Our reference: P-437150-H7T7
Contact: Kathryn Saunders
Telephone: (02) 4732 8567

Modification Application - Orchard Hills Waste Facility - Integrated Water and Leachate Plant Modifications - (MP09_0074-Mod-2)

Figure 2: Applicant's Site Plan.

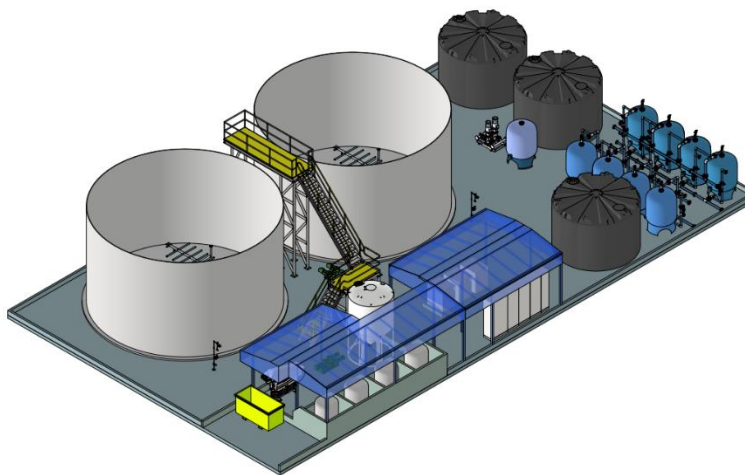
The plans and Modification Report do not detail the maximum heights of structures. It is recommended that DPE request the submission of a Visual Impact Assessment which demonstrates that the site will not have detrimental or detracting visual impacts in the location, as view from the future Metro corridor and from surrounding vantage points.

Elevation plans are to be provided for the Department's assessment and the materials and colours of all new tanks and infrastructure are to be nominated.

The suitability of the proposed location of the tanks and associated plant machinery close to the eastern side boundary is to be assessed, noting that

visual impacts may result. Passengers on the Metro line should not have a clear view of the treatment plant.
The applicant is to be requested to provide a View Impact Assessment (VIA).
